# UNITED STATES PATENT AND TRADEMARK OFFICE

APPLICATION NO.	FILING DATE	FIRST NAMED INVENTOR	ATTORNEY DOCKET NO.	CONFIRMATION NO.
10/777,464	02/11/2004	Samuel Morgan Peters	2657U.000001	2237

This is the first Office Action for application number 10/777,464 Reinforced Rod Holder, filed on 2/11/04. Claims 1-18 are pending.

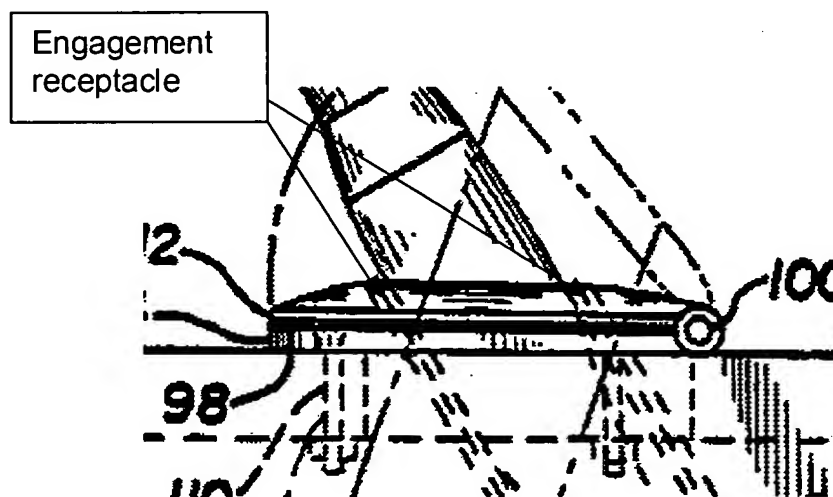
Potter, Jr. teaches a rod holder (10) which has an upper flange (12, 14) and a receiving socket (30) which teaches a liner (35) which extends from the upper flange

into the receiving socket, used to cushion the fishing rod handle during use, to prevent damage to the handle of the rod. Potter also teaches that the upper flange has an engagement receptacle (See Drawing Below), used for frictionally engaging the outer edge of the liner within the flange. Therefore, it would have been obvious to one having ordinary skill in the art at the time the invention was made from the teachings of Potter, Jr. to have added a liner in order to prevent damage to the fishing rod, during use, and to have added an engagement receptacle in the upper flange in order to frictionally engage the outer edge of liner to the device.
